Project	IEEE 802.16 Broadband Wireless Access Working Group < http://ieee802.org/16 >	
Title	Proposal to Amend Section 8.3.5.16 of TG3&4 Draft Document	
Date Submitted	2001-07-06	
Source(s)	Brian Eidson Conexant Systems, Inc. 9868 Scranton Rd San Diego, CA 92121	Voice: (858) 713-4720 Fax: (858) 713-3555 mailto: brian.eidson@conexant.com
Re:	TG3&4 Draft document	
Abstract	This document proposes a new section 8.3.5.16 to replace the old one in the 802.16ab draft document. Section 8.3.5.16 describes some example burst configurations and affiliated processing techniques within the Single Carrier mode.	
Purpose	To propose replacement of section 8.3.5.16 and its dependent, descending subsections with the contents of this document.	
Notice	This document has been prepared to assist IEEE 802.16. It is offered as a basis for discussion and is not binding on the contributing individual(s) or organization(s). The material in this document is subject to change in form and content after further study. The contributor(s) reserve(s) the right to add, amend or withdraw material contained herein.

Proposal to Amend Section 8.3.5.16 of TG3&4 Draft Document

Brian Eidson
 Conexant Systems, Inc.

Figure 1: Repetitive UW patterned Burst with 256 pt Prefix-aided FFTs and suffixing UW

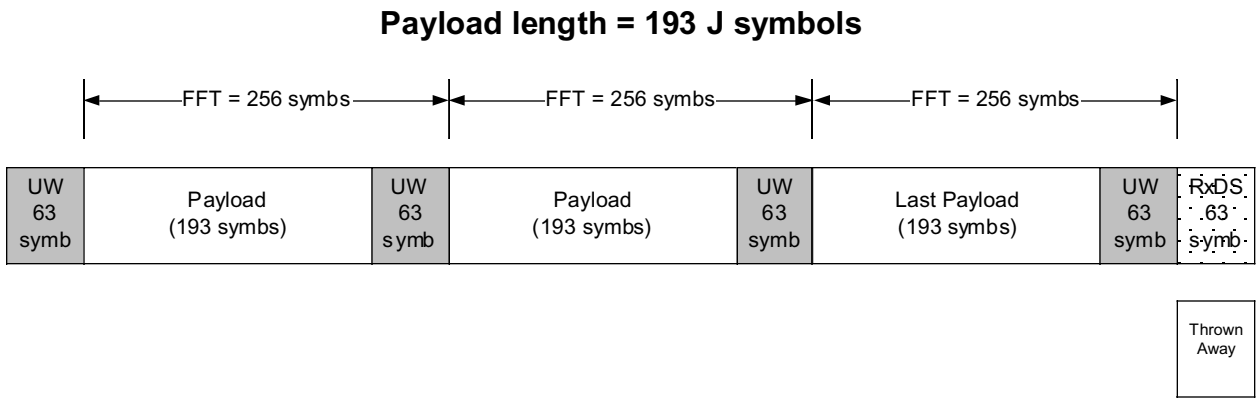
One standard signaling burst is involves the repetition of Unique Words (UWs), at regular intervals. Such repetition facilitates the FFT processing associated with frequency domain equalization. Figure 1 illustrates such a burst, which concludes with a (suffixing) UW, followed by a null transmit region, RxDS--which allows the delay spread to clear a receiver. Note that, for this signaling case, the payload length must be an integer multiple of 193 symbols. Note also the amount of overhead required, for both the repeated UWs, and for both the final UW and RxDS block. (No one can transmit while the delay spread is being cleared, although, in this case, this region could be used in the Rx/Tx transition gap switching.) The transmit efficiency (coefficient) for this case is $E = 193 J / (256 J + 63 N + 63)$, where J is the number of 193 symbol payload sections transmitted, and N is the number of Unique Words (1 or more) composing the (initial) acquisition sequence.

Figure 2: Repetitive UW Patterned Burst with 256 pt UW-aided FFTs and no suffixing UW

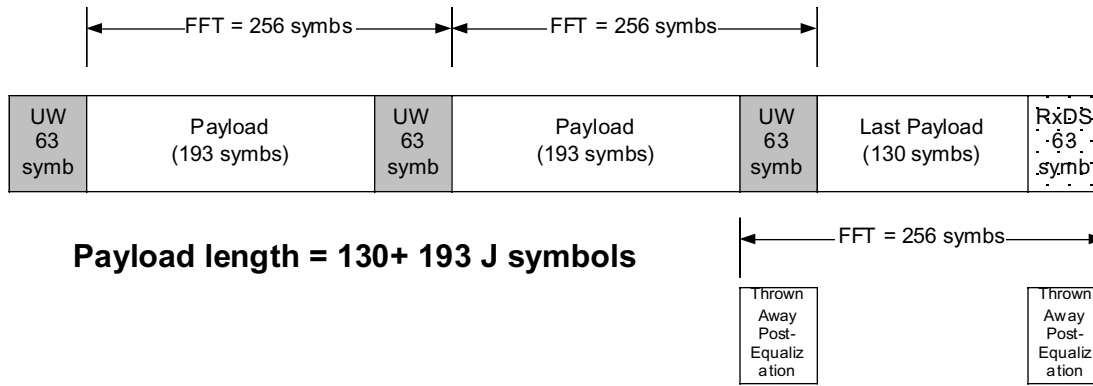
A slightly more efficient approach is to not transmit the last UW, as is illustrated in Figure 2. Observe that the last data payload is not cyclic, since it does not conclude with a Unique Word. Therefore, in order to perform FFT processing, the last FFT must overlap the earlier data by at least 63 symbols. What's more, some data must be thrown away, post-FFT. The payload length restriction in this case is that the payload must be M + 193 J symbols long, where J = 0,1,2, ... and M < 131 is the size of the final payload block. (Figure 2 illustrates the case of M = 130). Note that here the transmit efficiency is $E = (M + 193 J)/(256 J + 63 N)$, where J is the number of 193 symbol payload subblocks transmitted, and N is the number of Unique Words (1 or more) composing the (initial) acquisition sequence.

Figure 3: Burst with 256 pt Overlapping FFTs

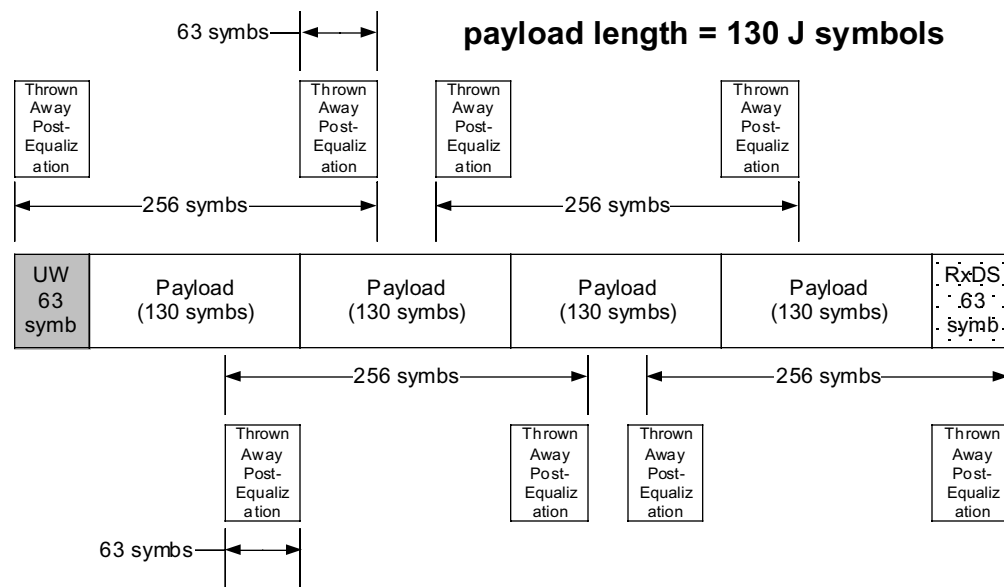
Since bursts tend to be short, the channel estimation performed at the beginning of the burst may be sufficient. What's more, overlap FFT processing is possible, so the repetitive UW-pattern may not always be necessary---if one is willing to use more FFTs to process a block. Figure 3 illustrates one example of how overlapping FFTs may be used in an overlap-save processing scheme. Note that the first and last 63 symbols of an FFT are eliminated, post equalization. The payload length restriction in the illustrated case is that the payload must be 130 J symbols long, where J = 0,1,2, ... Here the transmit efficiency is $E = (130 J)/(130 J + 63 N + 63)$, where J is the number of 130 symbol payload subblocks transmitted, and N is the number of Unique Words (1 or more) composing the (initial) acquisition sequence. Note that by increasing the overlap factor, the payload granularity may be decreased, so that payloads are M J symbols long, where $M < 131$. For this more general case, $E = M J / (M + 63 N + 63)$.

Figure 4: Burst with Overlapping 256 point FFTs, with overlap of last FFT increased.

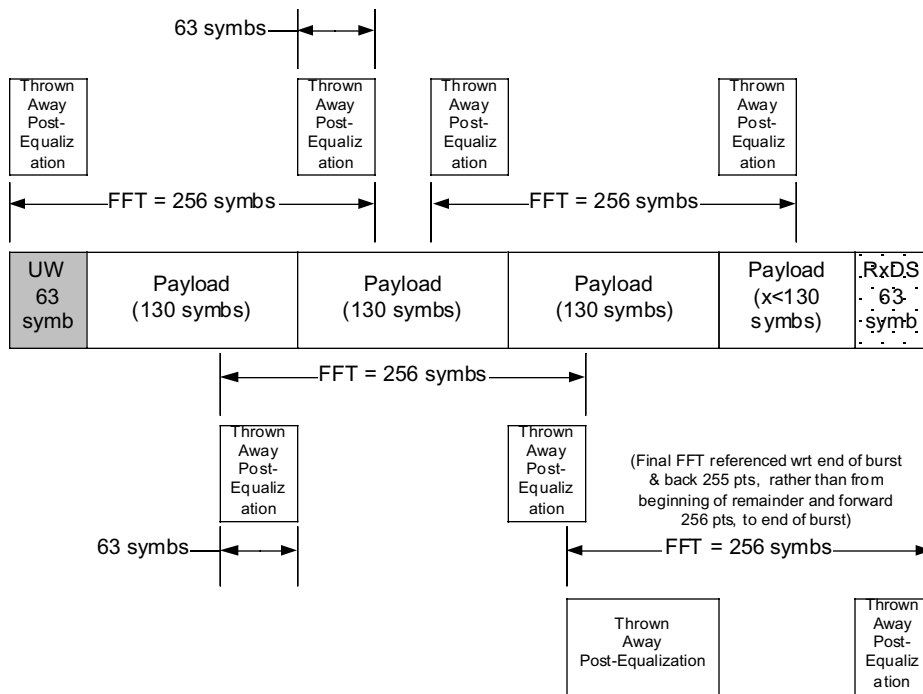
A variation on the aforesaid technique is to use regularly overlapping FFTs for the main data, and use an extended overlap to cover the last payload subblock, which may be smaller than the preceding payload subblocks. This approach is illustrated in Figure 4. Note that any arbitrary payload larger than 129 symbols can be accommodated with this approach. The transmit efficiency for this case is $E = \text{Payload Length}/(\text{Payload Length} + 63 N + 63)$, where N is the number of Unique Words (1 or more) composing the (initial) acquisition sequence.

Figure 5 : Burst with Regular Overlapping 256 point FFTs and zero-pad pre-FFT processing at the Receiver

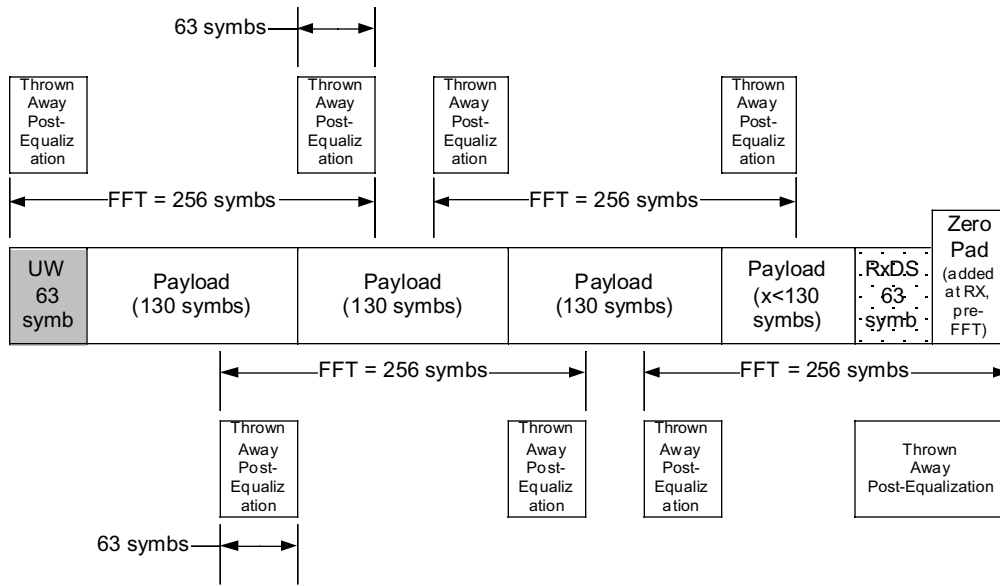
The technique described in Figure 4 is quite flexible in terms of payload sizes, but it does require the final FFT to back up in further time, to realize a larger overlap. A more regular FFT processing technique, with regular overlaps, might be better. A receiver processing technique that realizes this goal, using the same transmit format as used in Figure 4, is illustrated in Figure 5. Note that with this technique, the receiver insert zeros into the data stream following the RxDS delay spread clearing section, so that the final FFT is a full 256 points long. Mark that the transmitter does not transmit these zero pad symbols. The great advantage is that, with this technique, payloads of any size may be accommodated. Like the technique of Figure 4, the transmit efficiency is $E = \text{Payload Length} / (\text{Payload Length} + 63 N + 63)$, where N is the number of Unique Words (1 or more) composing the (initial) acquisition sequence. Note that, if addition pilot symbols are needed for channel estimation in long burst, Unique Words could be added to the payload stream of Figure 5, without the requirement that they be utilized within the data FFT processing. They may be still used to estimate the channel, using separate channel estimation processing.

Although not as efficient in terms of yielded data per FFT as the technique of Figure 1, the technique and frame format of Figure 5 is probably the most accepting and flexible in terms of payload sizes and transmit efficiency. Figure 6 illustrates how the technique may be applied to very short bursts, involving one FFT of data. Note that, even in these cases, a single 256 point FFT may be used, and payload sizes of 1 to 130 symbols can be supported, with high transmit efficiencies: $E = \text{Payload size} / (\text{Payload size} + 63 N + 63)$. No dummy data need to be added to the payload to fill out a block. This is particularly important for BW request messages, which are only 6 bytes in length, and would be sent with the most robust modulation, rate $\frac{1}{2}$ QPSK. Even with a very powerful rate $\frac{1}{2}$ Reed-Solomon outer code (N=12 bytes, K=6 bytes, T=3 bytes), and 6 tail symbols to terminate the inner code, the total number of payload symbols required, $X = 48 + 48 + 6 = 102$ symbols, could be easily accommodated within a single FFT, and transmitted without any payload bit stuffing.
